[Docket No. HM-190; Amdt. Nos. 171-96,  
173-206, 178-90]  
RIN 2137-AA72

Modifications to DOT Specification 21  
PF-1 Overpacks

**ACTION:** Final rule.

**§ 178.121-6 Typical assembly detail.**

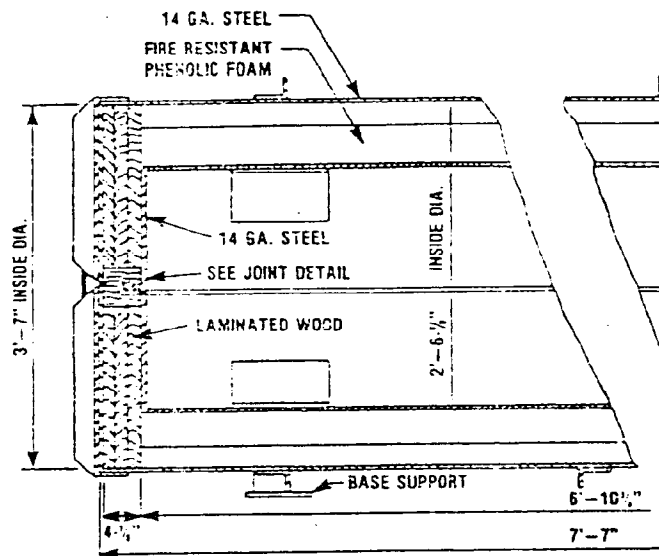
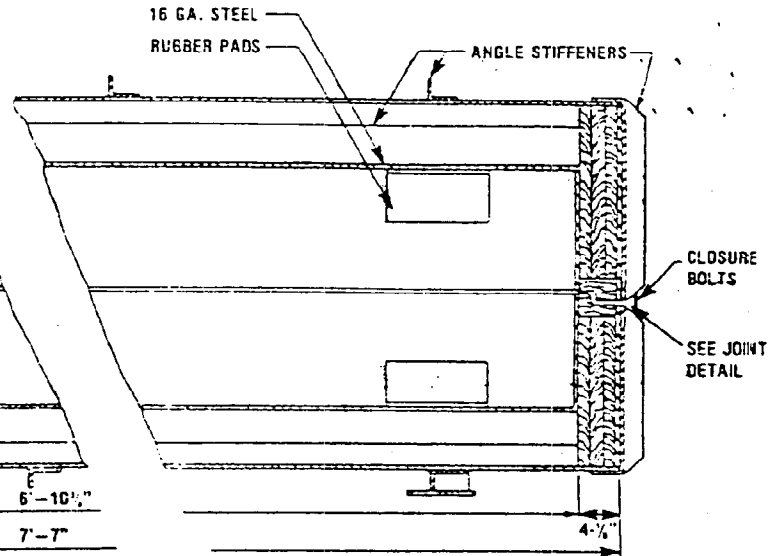
(a) Specification 21PF-1 (horizontal loading overpack).

(b) Specification 21PF-1A and 21PF-1B (horizontal loading overpack).

SECTION  
DOT SPECIFICATION 21PF-1A  
OVERPACK

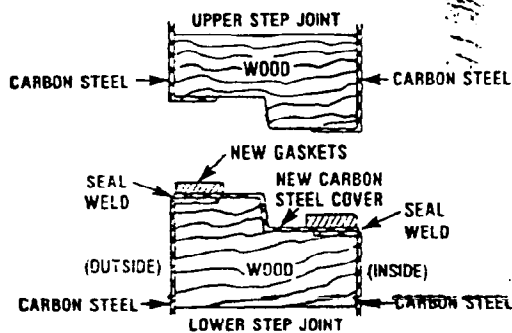
The first set of changes involves existing overpacks. The major changes are designed to remove (by drying) water which may be retained in the overpack, to drill drain holes in the external stiffener braces which tend to collect water, and to seal those joints which easily admit water. The sealing involves installation of a new joint cover and gasket, and application of a sealant compound to the stiffener joints and outer shell joints.

A carbon steel step-joint cover must be installed on the joint for the lower half of the overpack where experience indicates that water accumulation has been most significant. Step joint gaskets have been changed from a vinyl foam or expanded rubber to either a Silastic E RTV rubber or a silicon sponge. Inspection for wood warpage is required.

SECTION  
DOT SPECIFICATION 21PF-1B  
OVERPACK

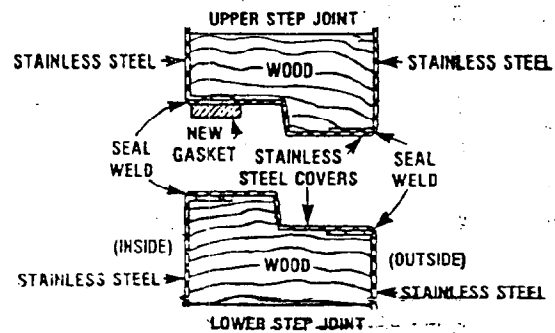
The second part of the amendment involves future construction of DOT 21PF-1 overpacks. These design changes are more comprehensive than those proposed for existing overpacks. The most significant of these changes involve (1) use of stainless steel instead of mild (carbon) steel for the metal shell, and (2) the step-joint at the overpack closure is reversed from a step-down to step-up joint. Continuous welds will assure the integrity of body seams and joints for the liner, shell, and step-joint. Welding requirements and welder qualifications are similar to those required for existing overpacks.

steel, thereby eliminating the need for painting the metal for weather resistance. The wood step-joint must be covered with stainless steel painted with a fire-retardant (intumescent) paint.
